THE WARNER AIRCRAFT CORPORATION  
20263 Hoover Avenue  
Detroit 5, Michigan

SERVICE LETTER NO. A-17

Subject: I. Replacement of S-506 Cylinder Hold-Down Stud and Nut N-511 with S-911 Stud and N-910 Nut.  
II. Replacement of Gasket between Cylinder Barrel and Crankcase with an "O" Type Ring.

FIG. 2-a

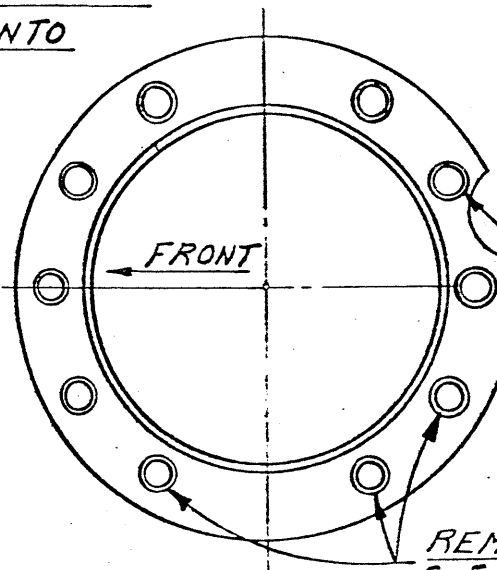
- (5) Due to the fact that both ends of the replacement stud have a  $3/8$  - 24 thread with the exception of the S-506 + .062 and S-776 + .062 which have a  $7/16$  - 20 thread, the stud end or the end which must be screwed into the crankcase has been identified with a  $1/8$ " diameter countersink in the center of the stud end as shown in Figure 2. Extreme care must be exercised to insure the countersunk end of the stud is screwed into the aluminum, and after the studs are installed, an inspection should be made of the protruding ends of all of the studs to make certain that no countersink appears on them.

$\frac{1}{8}$  DIA. C'SINK  
INDICATES STUD  
END TO BE SET INTO  
C'CASE.

FIG. -3

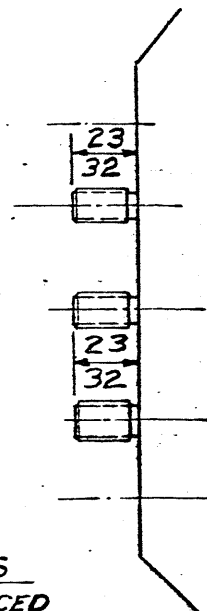
- (6) After the proper studs have been selected, they should be set into the crankcase with a minimum torque of 50 inch pounds and a maximum torque of 275 inch pounds. If the torque exceeds this maximum, the pitch diameter may be reduced by etching as outlined in Service Letter A-15 or the pitch diameter of the tapped hole may be increased by the use of an oversize pitch diameter tap. All studs must be set to a height of  $23/32$  from the face of the crankcase as shown in Figure #3.

FIG. - 4

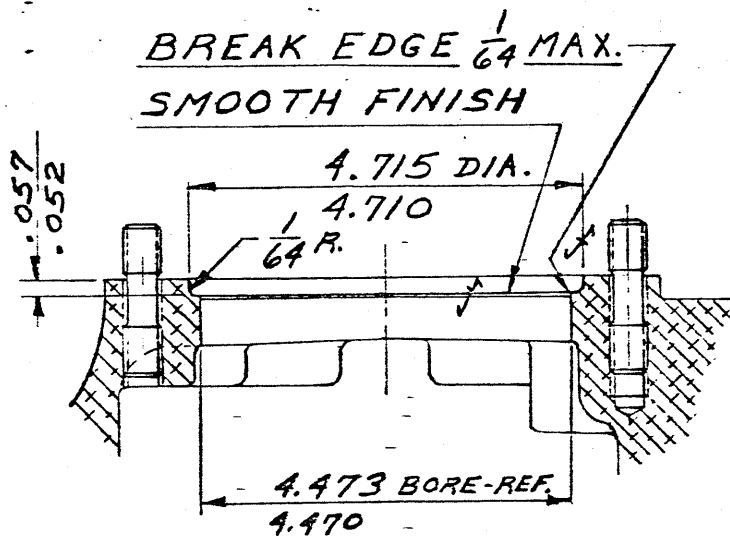
- (1) To modify the crankcase for use with an "C" type ring, it is necessary that the crankcase be assembled on the bench with the crankcase bolts sufficiently tight to line up the front and rear halves of the crankcase and hold them tightly together. A hand-operated counterboring tool, Warner Part #FA-11127 is available for sale to authorized service stations to modify Warner Engines, Models Scarab Jr. and Scarab, in service for use with "C" Ring #11195 as shown in Figure No. 4. Counterboring tool,

- (2) While the crankcase remachined in service will have counterbores as shown in Figures 4 and 5, crankcases received from the factory may have countersinks instead. In either case, however, the "O" rings specified will fit properly.

DIMENSIONS OF C'BORE  
TO BE CUT ON WARNER

4  $\frac{1}{4}$  BORE ENGINES.

FOR USE WITH 4  $\frac{1}{4}$  I.D. X  $\frac{1}{16}$

"O" RING-WARNER PART #11195.

WARNER TOOL # FA-11127

MAY BE USED.

FIG. -5

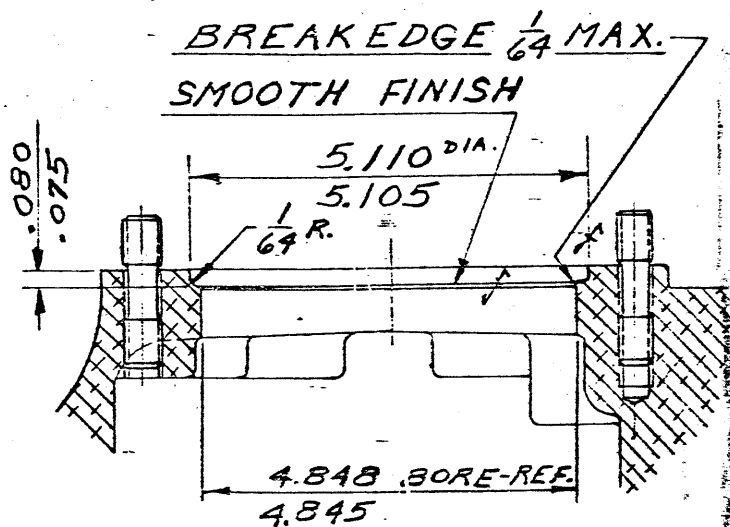
Warner Part #FA-11177 is also available for modifying other Warner Engines, Models Super-Scarab Ser. 40, 50, and 50A and Model 165 in service for use with "O" Ring #8566, Figure No. 5.

DIMENSIONS OF C'BORE  
TO BE CUT ON WARNER

4  $\frac{5}{8}$  BORE ENGINE.

FOR USE WITH 4  $\frac{5}{8}$  I.D. BY  $\frac{3}{32}$

"O" RING-WARNER PART #8566.

WARNER TOOL # FA-11177

MAY BE USED.
